Town of Parker Community Development Department
 Development Review Division
 Attention: **Amber Wood Hicken**

Application Type: **Site Plan – Non-Residential**
 Status: **First Referral**
 Application Name: Parker & Pine F1 L1 - In-n-Out Burger
 Case/AP#: **SUB22-063**
 Referral Received: February 8, 2023
 Comments Due: March 8, 2023

Review date: **February 28, 2023**
 Plan reviewer: **Randall L. Capra, rcapra@parkeronline.org**
 Phone: 303.805.3163

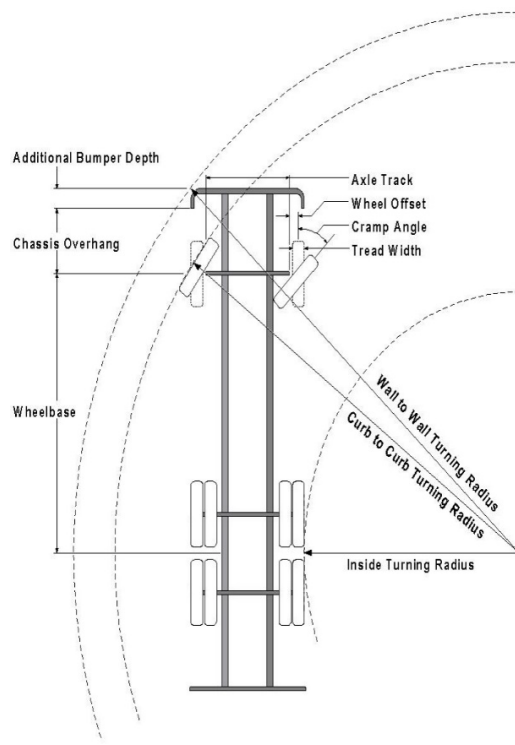
4. Per the requirements of [21 IFC Section 503.1.1 Buildings and Facilities] approved fire apparatus access roads shall be provided for every facility, building, portion of a building hereafter constructed or moved into or within the jurisdiction. The fire apparatus access road shall comply with the requirements of this section and shall extend to within 150 feet of all portions of the facility and all portions of the exterior walls of the first story of the building as measured by an approved route around the exterior of the building or facility (the building, as approximately 4,000 sf (or 40'x 100') cannot meet the requirement as measured from the center line of the fire apparatus as measured by an approved route from any point that a fire engine might park when responding to a call at this building).

Per the requirements of the code, the fire code official is allowed to increase the dimension of the 150 feet provided that the applicant meets Exception 1.1 of this section... "The building is equipped throughout with an approved automatic sprinkler suppression system installed in accordance with section 903.1.1, 903.1.2, or 903.3.1.3; a sprinkler suppression system will be required. The building is to be sprinklered per pre-application meeting discussions. **Note – This issue was satisfied by the applicant when reviewed through the SP21-126 submittal process.**
